INFORMAL DRC

KNOX & AMERICAN

EROSION AND SEDIMENT
CONTROL PLAN - PHASE 1

CONCEPT
1ST FLOOR
PLAN

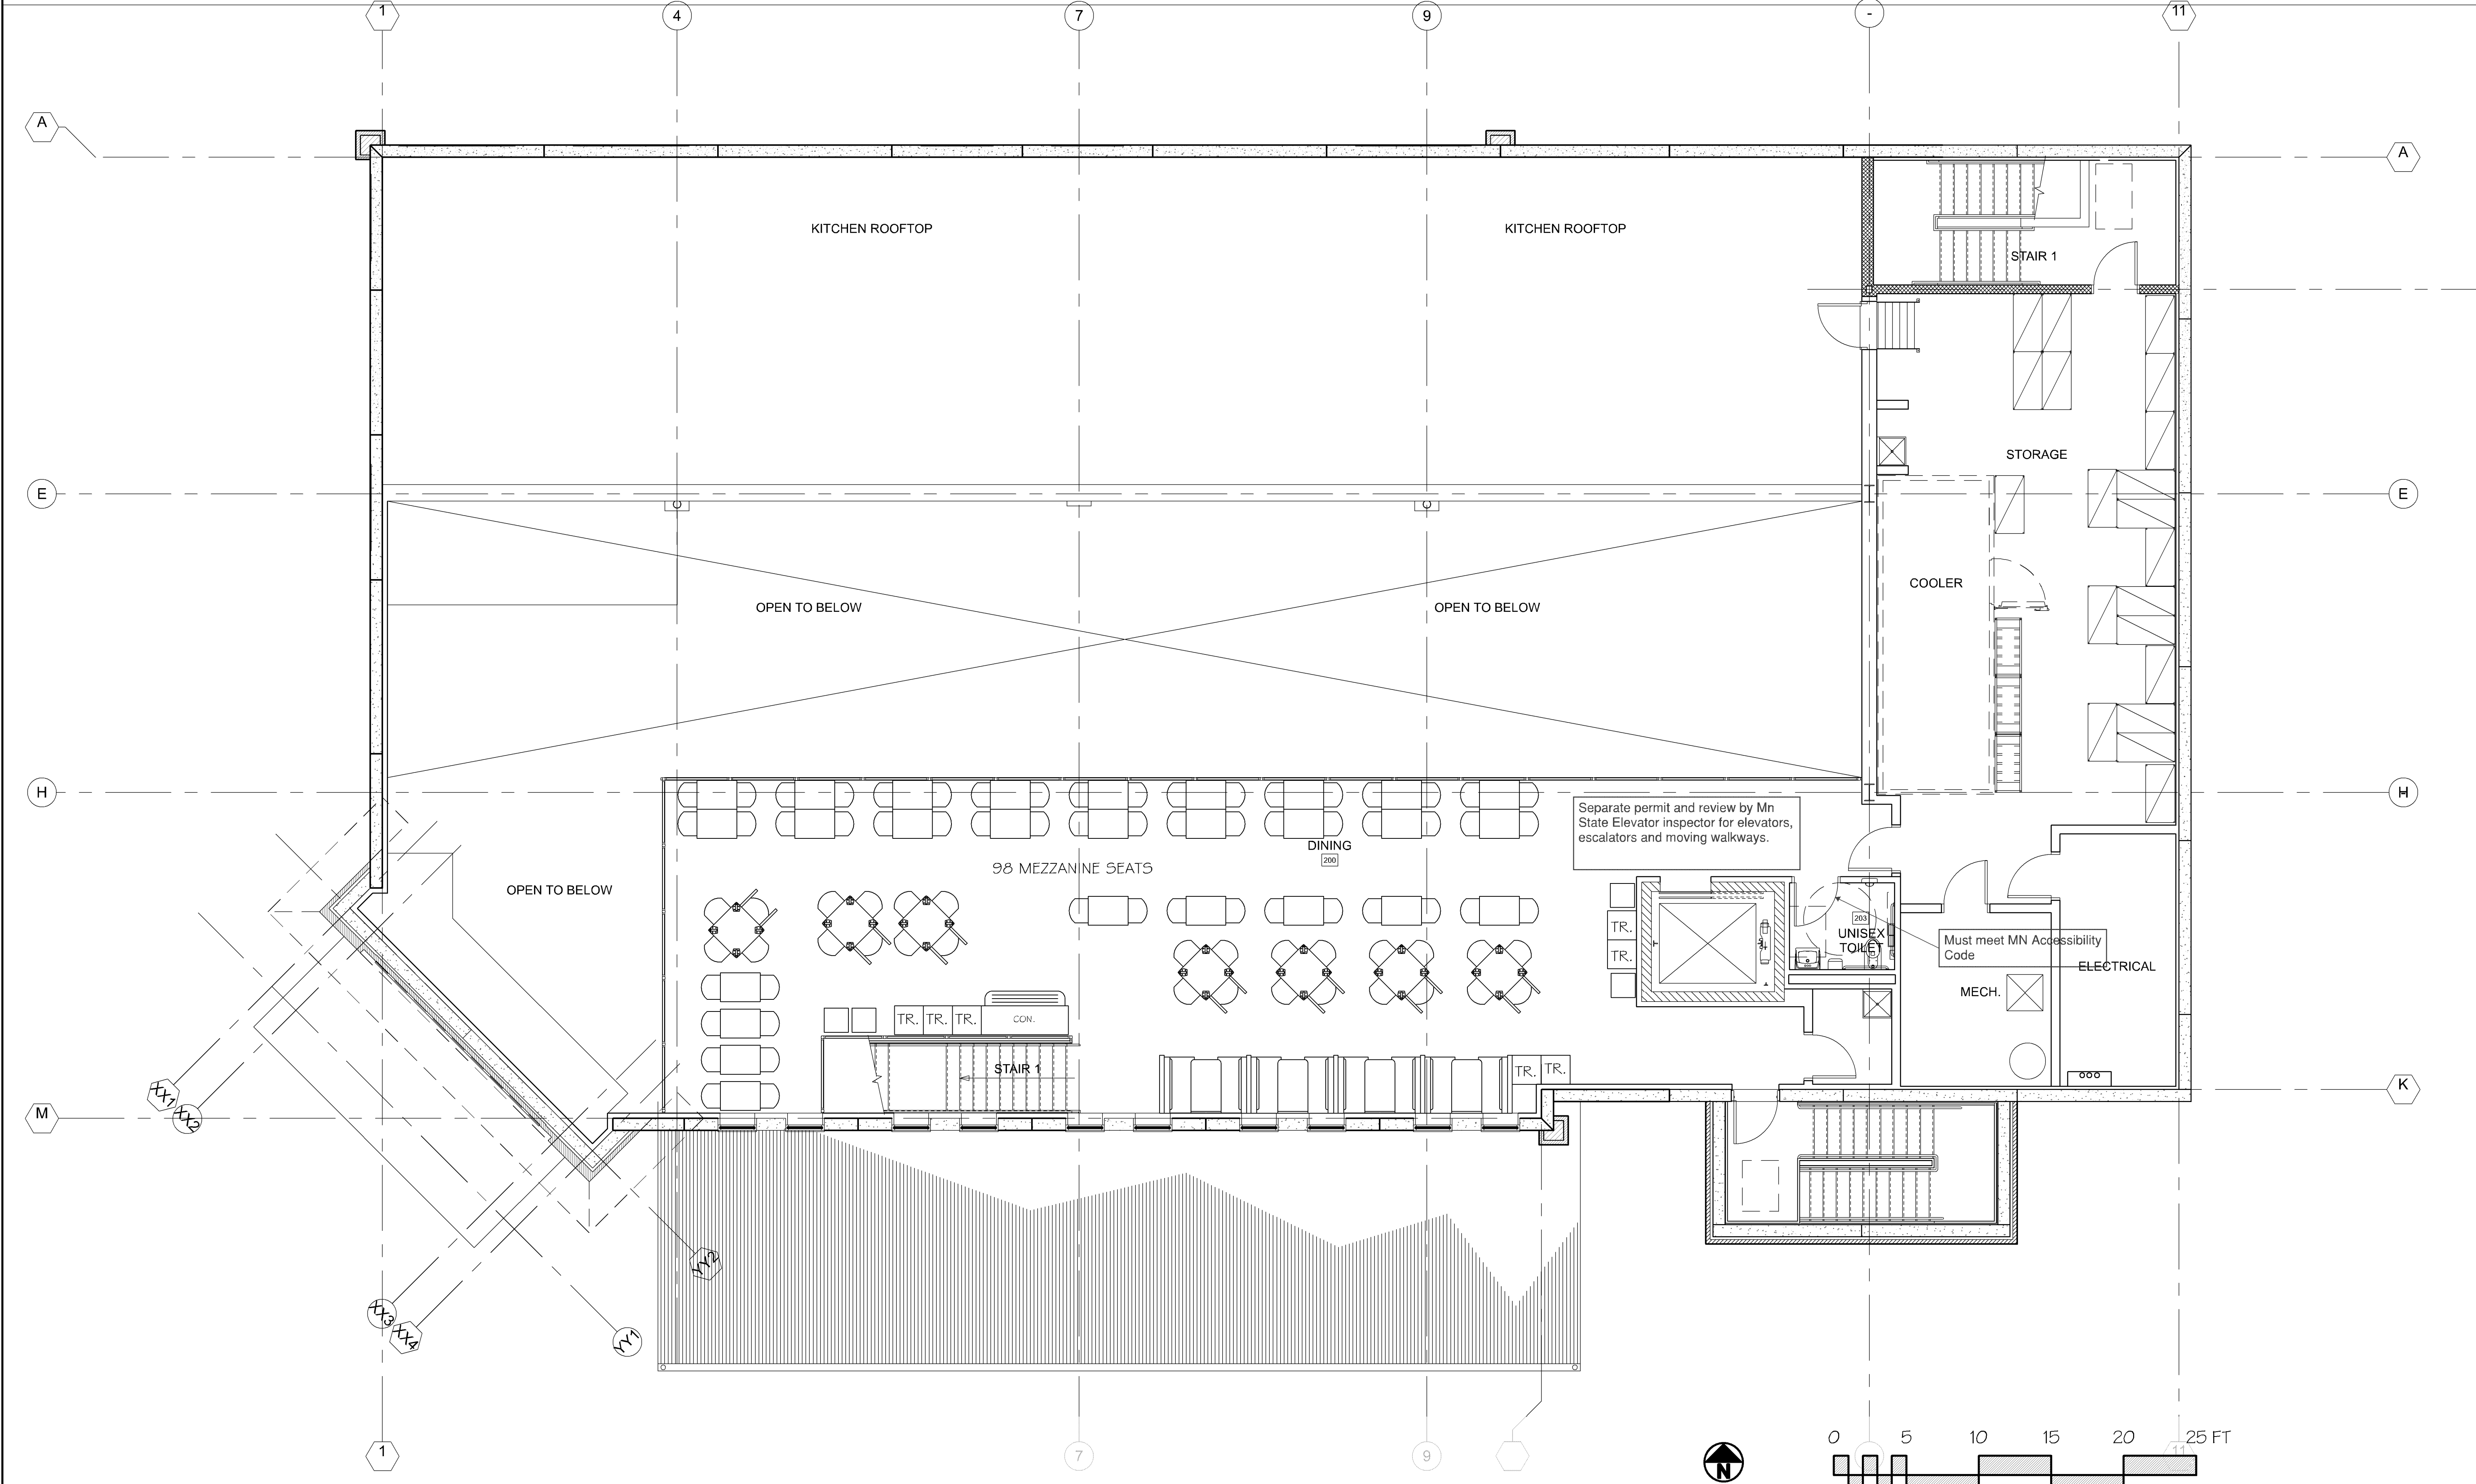
Insure kitchen hood suppression system is an approved UL300 listed system connected to the building sprinkler system.

Provide reliable heat in room.

Separate permit and review by Mn State Elevator inspector for elevators, escalators and moving walkways.

Must meet current MN State Building Code

2 NORTH - DRIVE THRU ELEVATION
A-4.1 Scale: 3/16" = 1'-0"

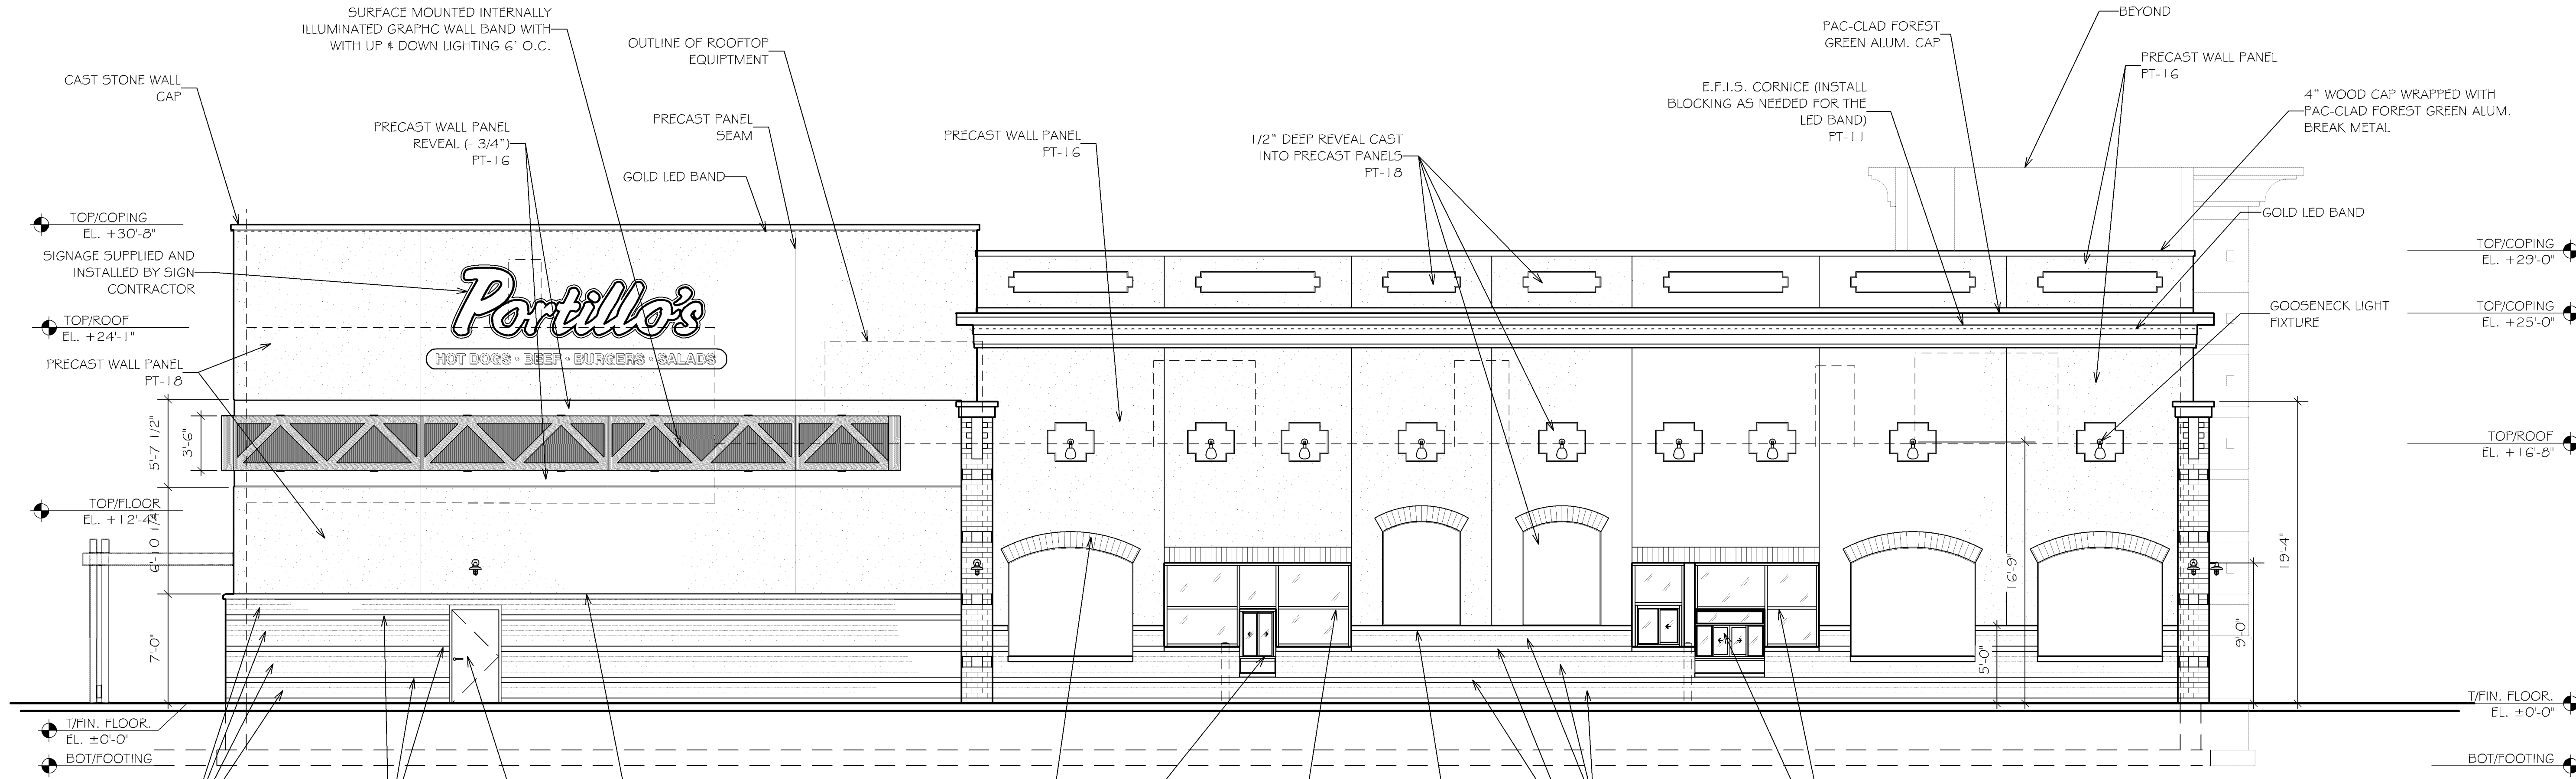
The ground level portion of a building facade between two feet and ten feet above grade must consist of a minimum of 25% transparent windows, including windows on entrances (Sec. 21.301.03).
